Model: Z-C1:GW	Date: 12-Nov-10	No.: RM028001a
----------------	-----------------	----------------

Subject: Firmware Release Note:Web Uapl		Prepared by: T. Kiyohara	
From: MFP/Printer Tech Service Dept., 2nd Tech Service Sect.			
Classification:	<input type="checkbox"/> Troubleshooting	<input type="checkbox"/> Part information	<input type="checkbox"/> Action required
	<input type="checkbox"/> Mechanical	<input type="checkbox"/> Electrical	<input type="checkbox"/> Service manual revision
	<input type="checkbox"/> Paper path	<input type="checkbox"/> Transmit/receive	<input type="checkbox"/> Retrofit information
	<input type="checkbox"/> Product Safety	<input checked="" type="checkbox"/> Other ()	<input checked="" type="checkbox"/> Tier 2

This RTB has been issued to announce the firmware release information for the **Web Uapl**.

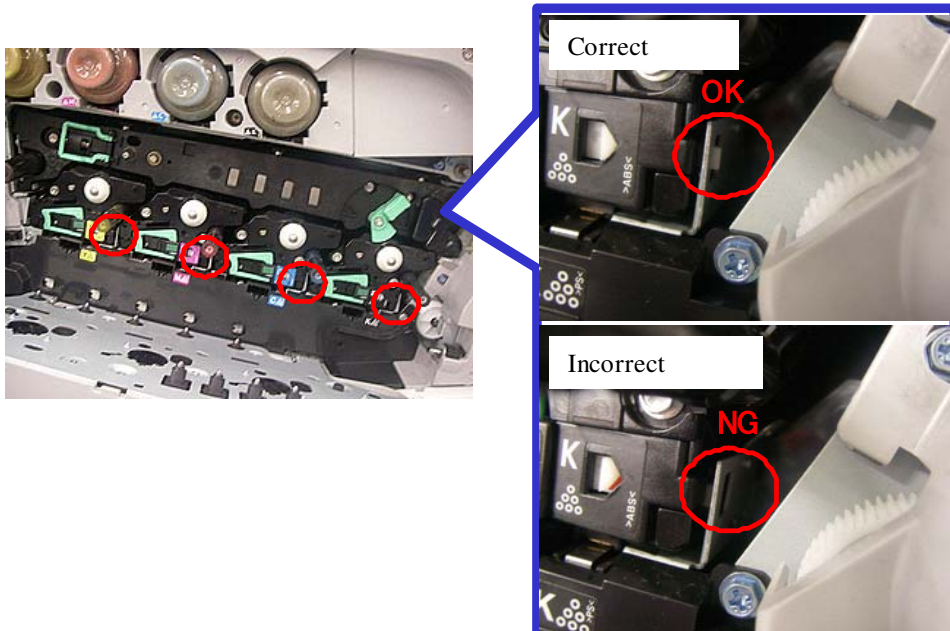
7. Make sure that the white locking tab on the PDCU (circled in red below) is inside the hole in the bracket. Do this for all four PDCUs.

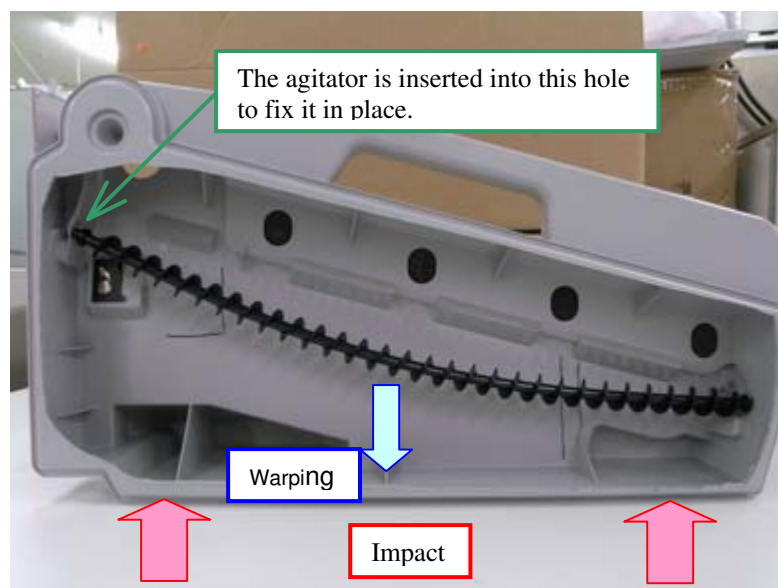
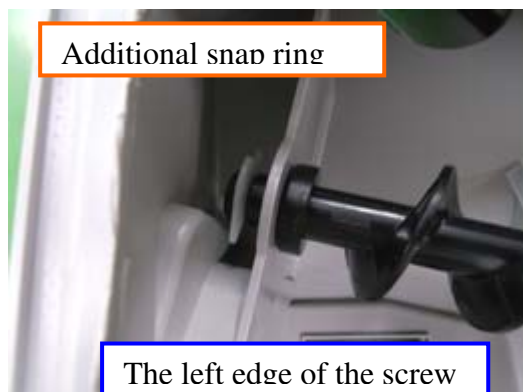
The screw (agitator) for the waste toner bottle is dislodged out of position (occurs at installation).

A snap ring was added, so that the tip of the agitator cannot pop out of the hole.

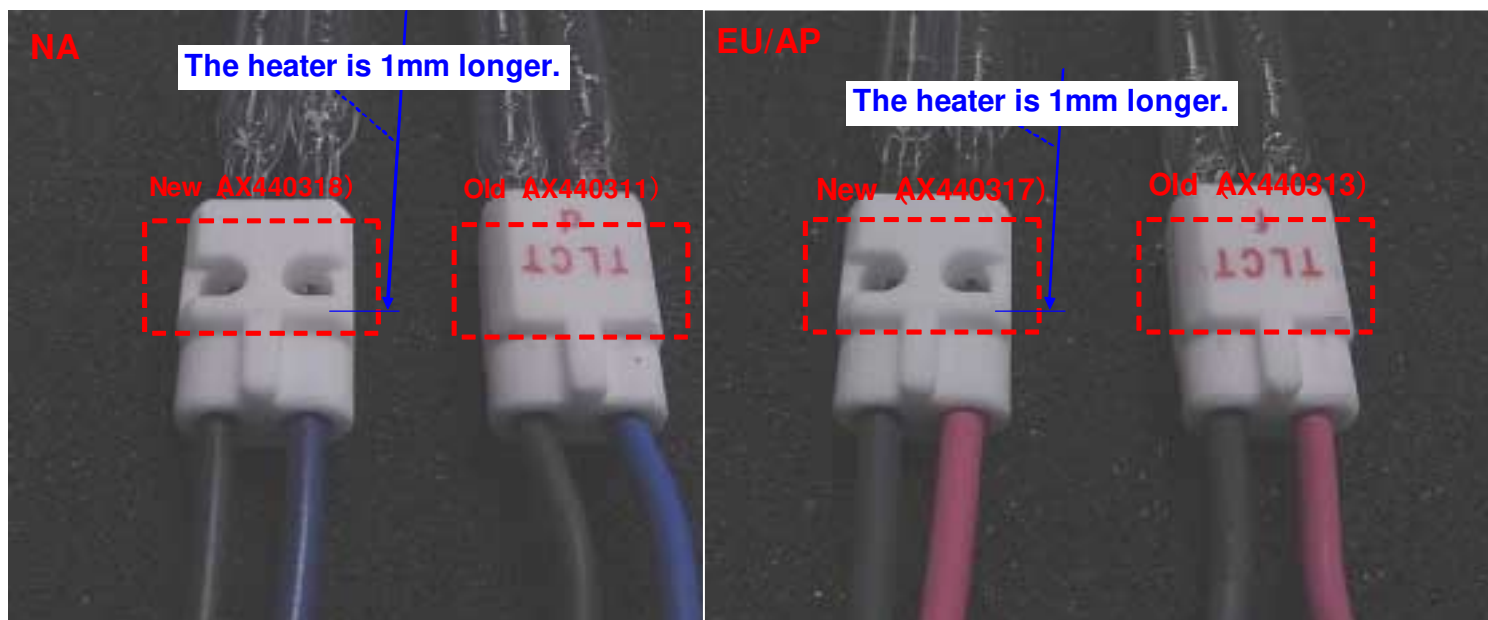
Note: The following shows the differences between the old and new parts.

- The shape of the sockets and the length of the heater are different.

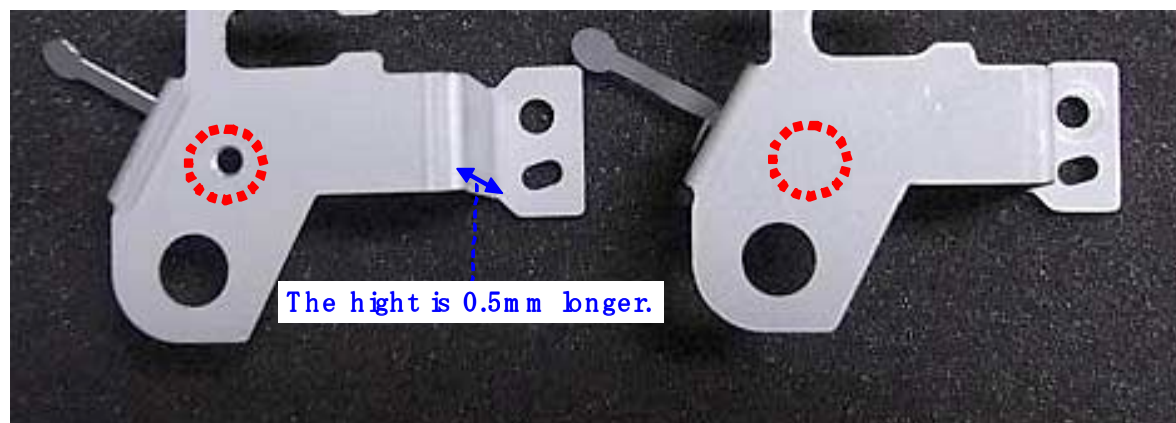
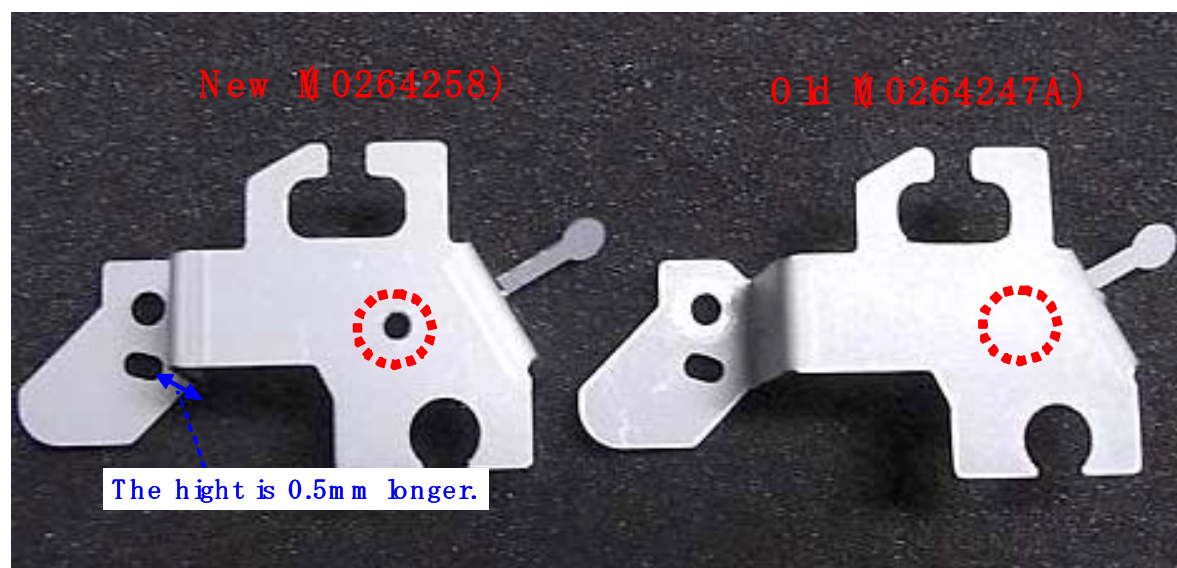
- The new part has an additional hole and the area shown below is 0.5mm higher.

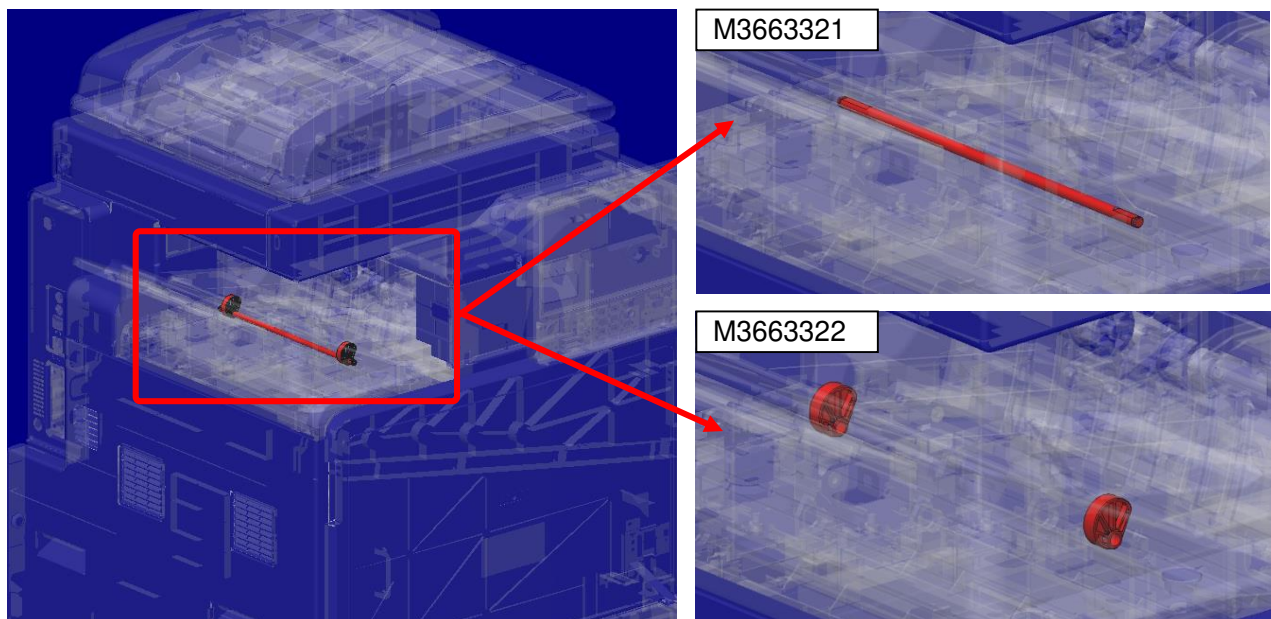
Change: The shaft with cam for the ass'y part is no longer available as a service part, and the shaft and the cam have been registered as individual parts.

Old part number	New part number	Description	Q'ty	Int	Page	Index	Note
M3663320		CAM:TRAY:MOVEABLE:ASS'Y	-	-	-	-	Delete
	M3663321	SHAFT:CAM:TRAY	-	-	-	-	Add

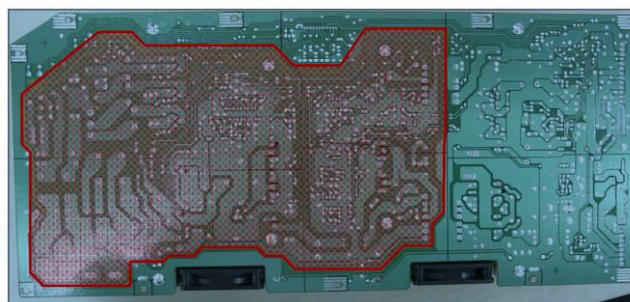
NEVER touch the areas outlined in red in the photos below to prevent electric shock caused by residual charge.

Residual charge of about 100V-400V remains on the PSU board for several months even when the board has been removed from the machine after turning off the machine power and unplugging the power cord.

The areas outlined in red on the bracket shows where a residual charge of about 100V-400V remains on the PSU board under the bracket.

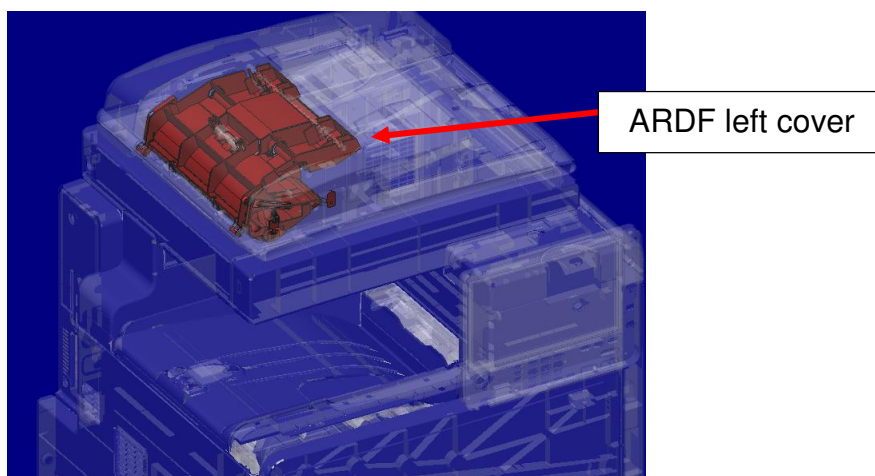
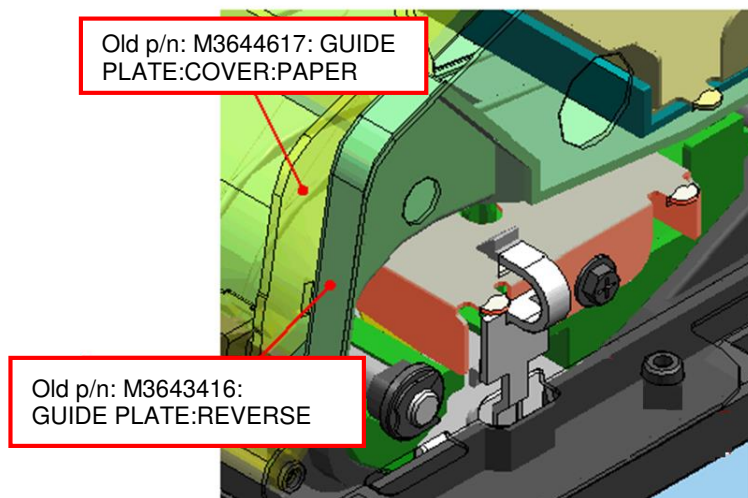
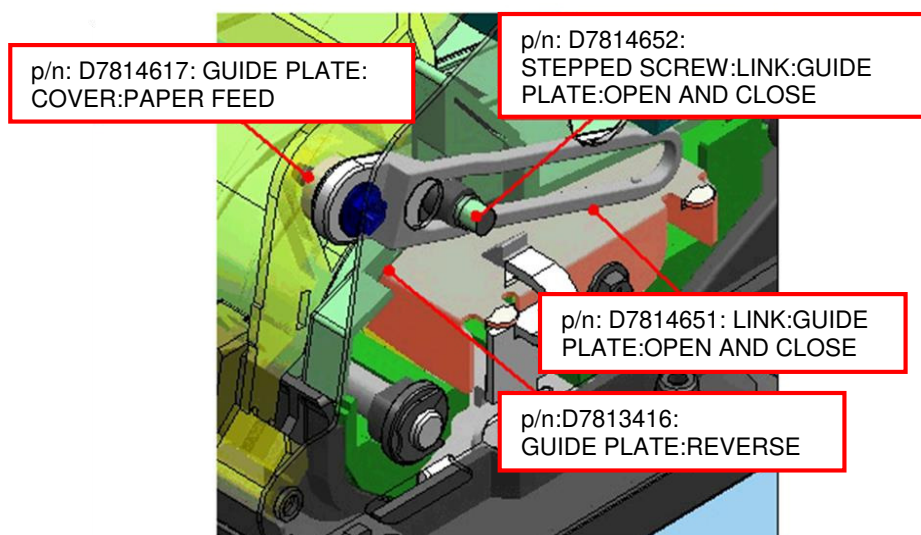
A linking part was added (in between the guide plate and side plate) to prevent the cover from opening too much.

Before the modification

After the modification

The new linking part cannot be attached to machines manufactured prior to this modification, because the side plate does not have the screw hold and the side plate is not available as a spare part.

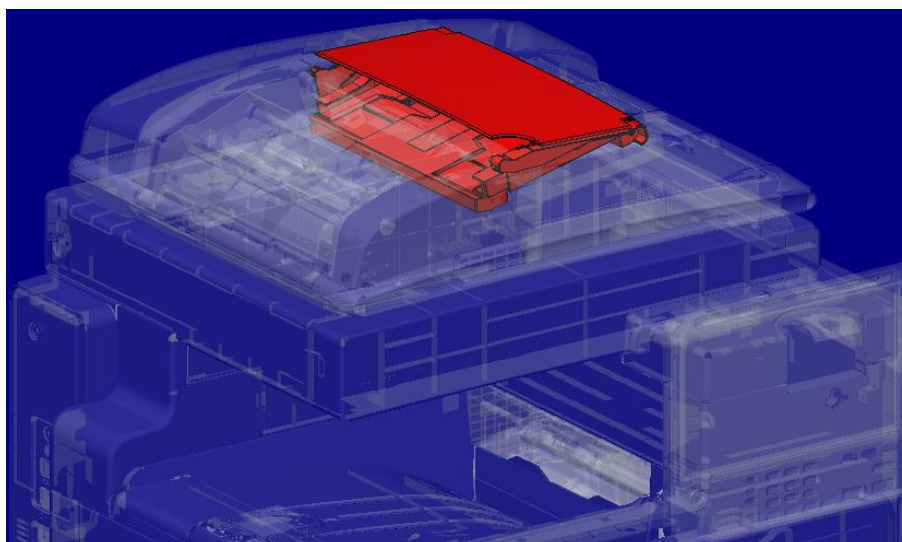
- When you attach P/N **D7834730**, make sure to attach it **together with D7816021 and D7816011 as a set**. This is because D7834730 does not include D7816021 and D7816011.
